REPORTS OF
CONSULTING BOARD
ON
LAKE HODGES DAM
SAN DIEGO COUNTY, CALIFORNIA

Report to State Engineer

on Lake Hodges Dam

March 11, 1929.

COMPUTED SOIL PRESSURES
FOR DAM WHEN ASSUMED TO
BE DIVIDED BY CRACK INTO
TWO PORTIONS.

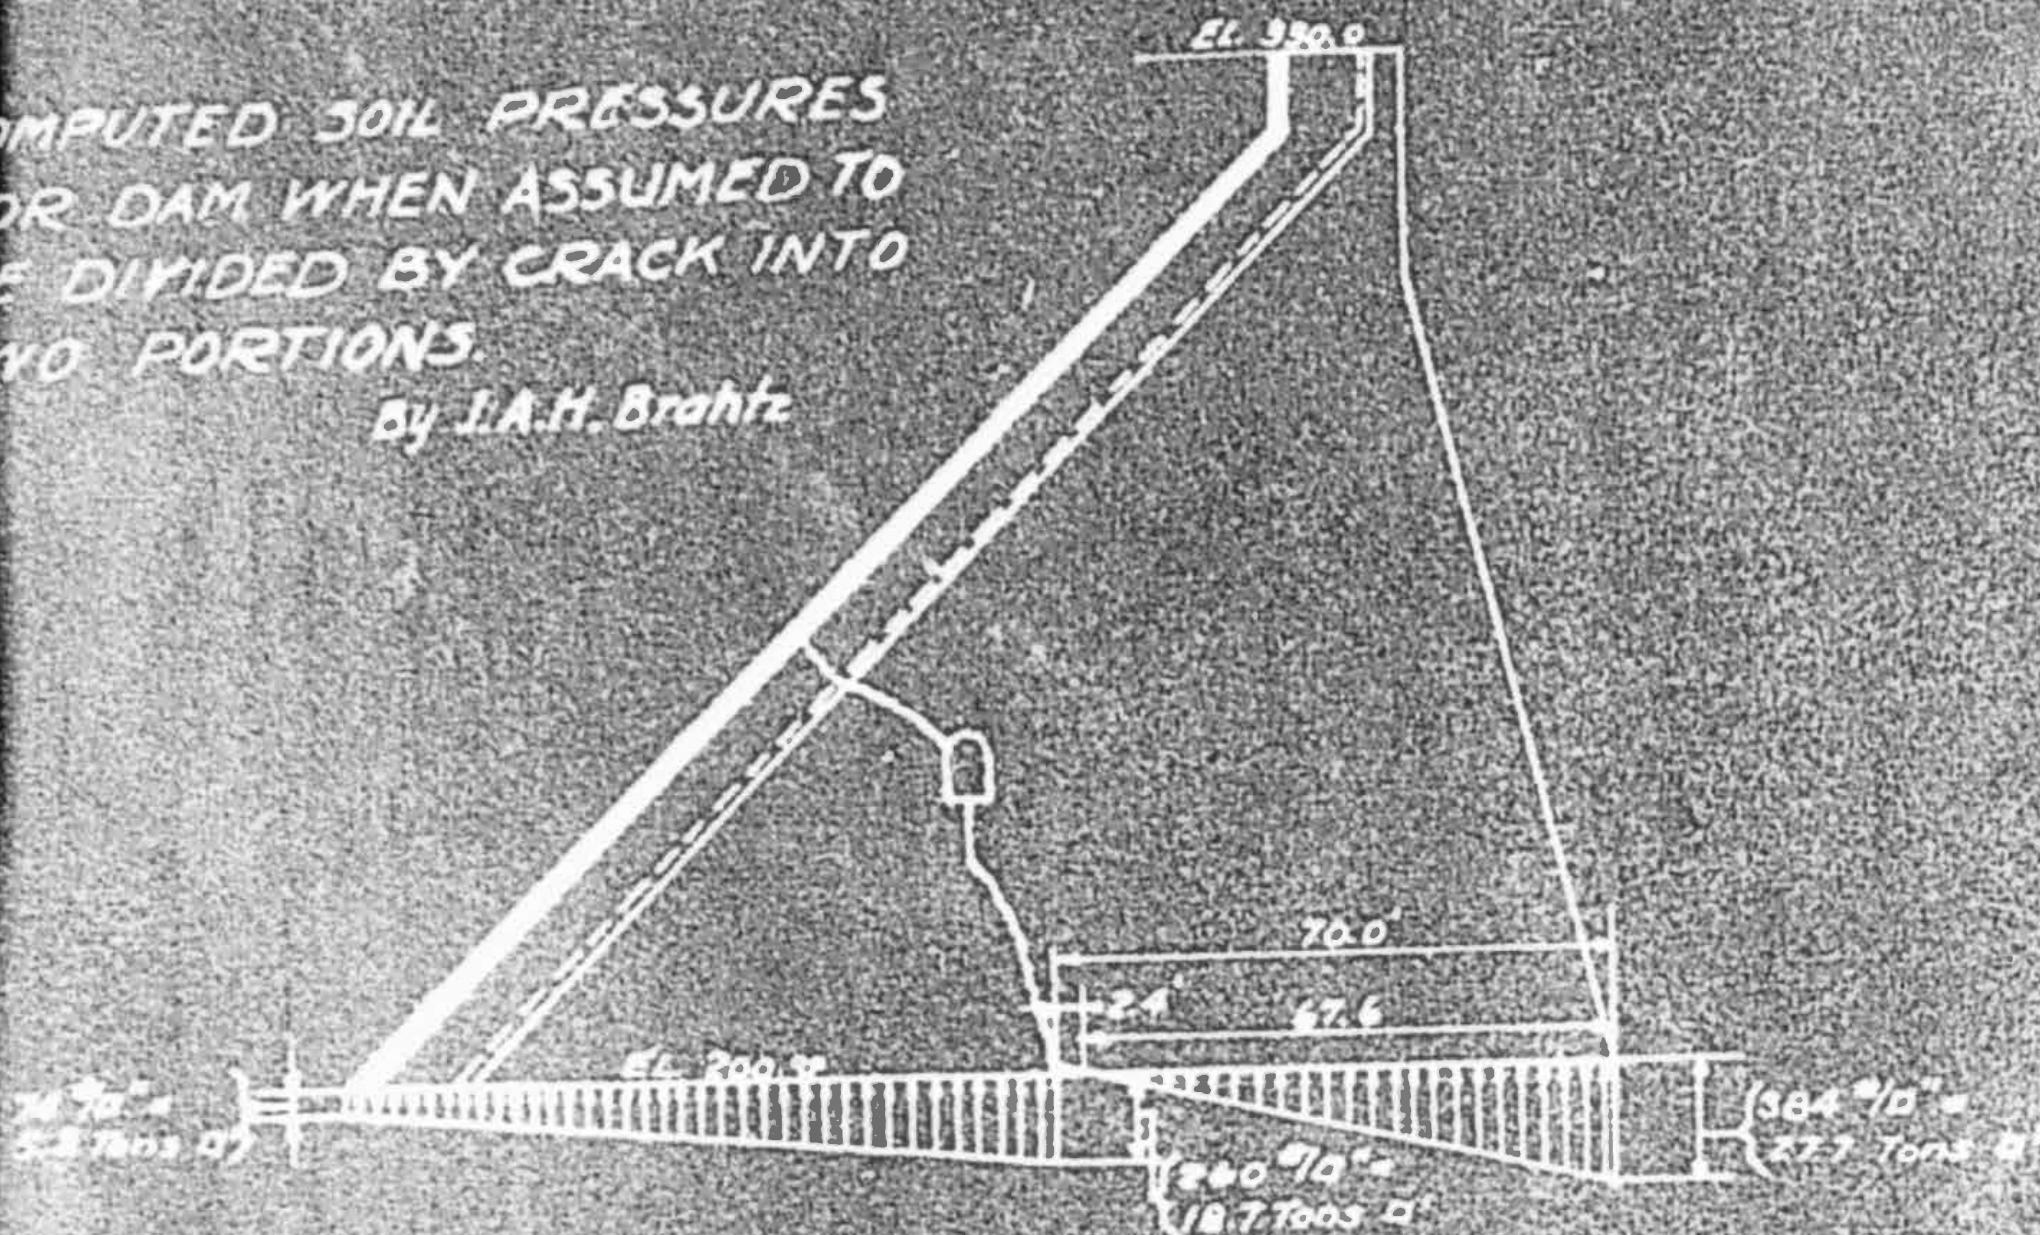
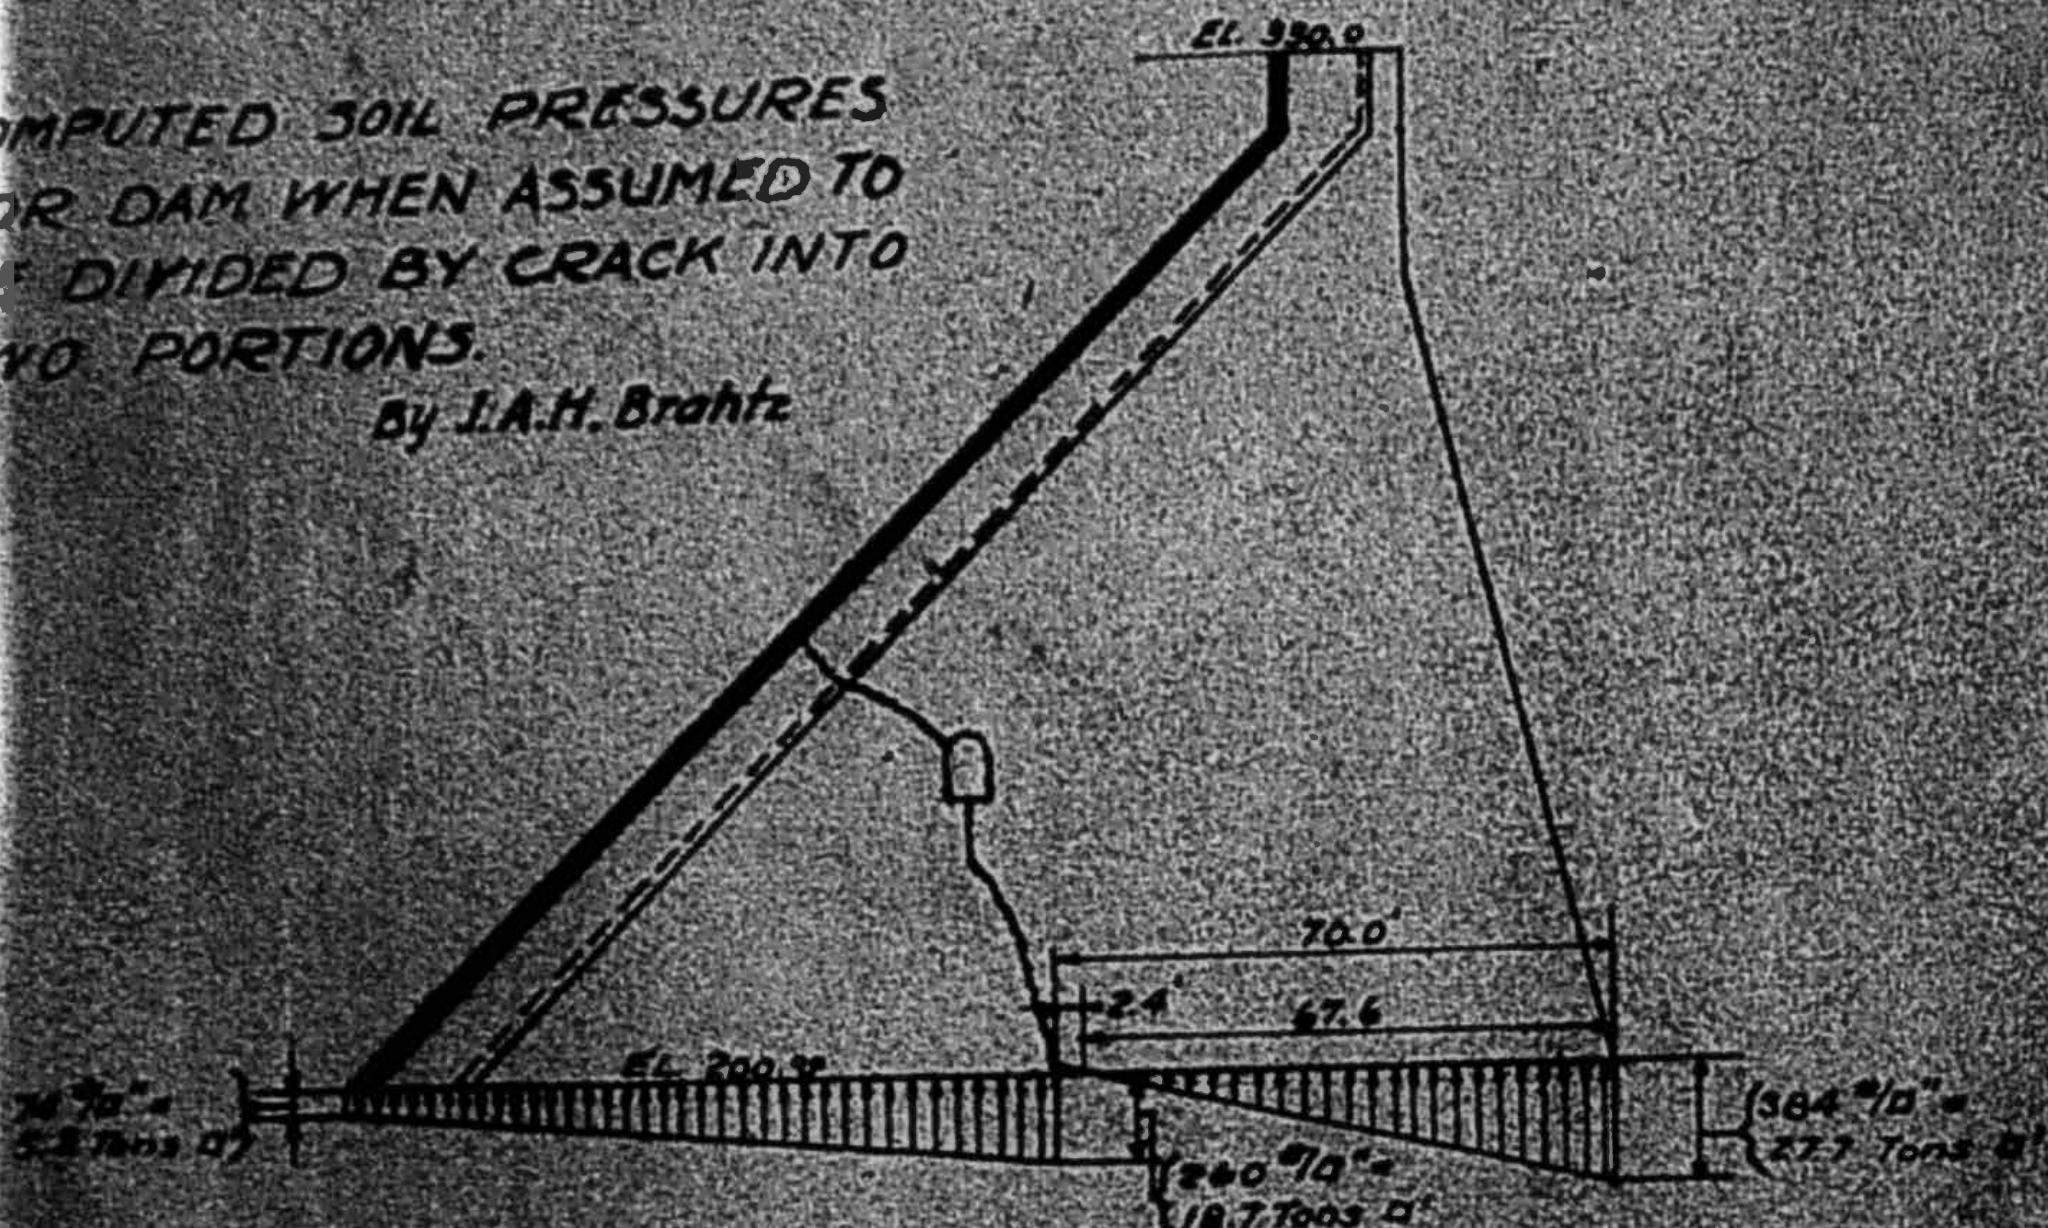
Mr. Brahtz has made a comprehensive study of the stresses which would result on several horizontal sections of the buttresses at different elevations for two possible conditions which may result from the cracks. In one case he assumes that the cracks extend upward clear through the arch barrel and downward to the foundation. In the other case he assumes that the arch barrel at the extension of the cracks would resist a tension of approximately 50 pounds per square inch. He obtains the following results for the properties and stresses on the horizontal section at Elevation 200, at the base of the tallest buttress:

This analysis, together with the studies of Mr. Dewell, show that while the distribution of the foundation pressures would be changed, the maximum pressures resulting therefrom would not be excessive.
